NORANDA AIR-BREAK SWITCH INSTALLATION - PHASE I IESO EXPEDITED ASSESSMENT– REVISED (CAA ID 2005-EX224)

NORANDA SUB-STATION REPLACEMENT - PHASE II IESO EXPEDITED ASSESSMENT – REVISED (CAA ID 2005-EX224)

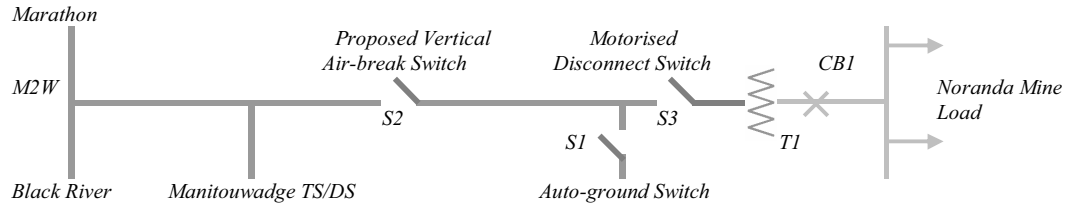
This assessment has been conducted to examine the impact on installation of a manually-operated, new vertical air-break disconnect switch S2 (as shown below) at Noranda Inc. GECO division site at Manitowadge.

The new switch S2 will be kirk keyed to the circuit breaker CB1 located at the LT side of the 132/4.16 kV step-down transformer such that the switch S2 will not be opened unless the breaker CB1 is opened.

Presently, the faults at step-down transformer T1 are not effectively seen by the terminal breakers of the 115 kV circuit M2W. Thus, those faults activate a differential protection across the transformer which in turn activates a lockout relay. The lockout relay closes the auto-ground switch S1. Due to the resulting ground fault, M2W terminal breakers would now open. In future, above fault clearing mechanism will continue, but the new switch S2 can be manually opened provided the breaker CB1 is opened by the transformer fault, in case M2W to be re-energized while Noranda site is isolated.

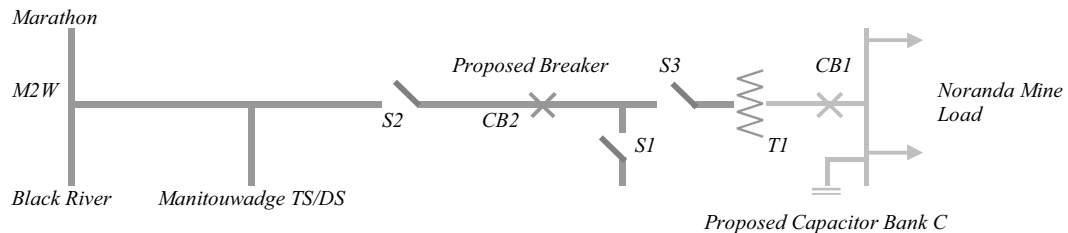
- installation of an outdoor circuit breaker CB2.
- replacement of existing lightning arresters in the transformer primary, neutral grounding resistor at the transformer secondary, cable bank from the transformer secondary to switchgear line-up and the revenue metering equipment with similar new equipment.
- installation of a motorized operator on the air-break switch S2.
- installation of a 4.16 kV, 150 kVAr capacitor bank C for power factor correction.

The point of connection to the IESO-controlled grid will remain same, hence will continue to be supplied via the 115 kV circuit M2W from Marathon. In future, the faults on M2W will be cleared by CB2 at Noranda end and the faults on the step-down transformer will be cleared by CB1 and CB2.

In order to control the power factor at 115 kV bus to at least 0.9 lag, it will be required to control the power factor at the 4.16 kV bus to about 0.93 taking reactive losses in the transformer in to account. In order to accomplish the above requirement, the analysis shows a planned 150 kVar capacitor bank at 4.16 kV bus will not be sufficient, and at least 200 kVar capacitor bank with suitable steps will be required at the 4.16 kV bus.

1. The registration of the new equipment to be installed will need to be completed through the IESO's facility registration process.
2. In order to meet (a) of Section 5.0, it will be required that a capacitor bank of minimum 200 kVAr with suitable steps to be installed at 4.16 kV bus such that the power factor at 115 kV bus can be controlled to minimum 0.9 lag.
3. The applicant is required to comply with (b) and (c) of Section 5.0.
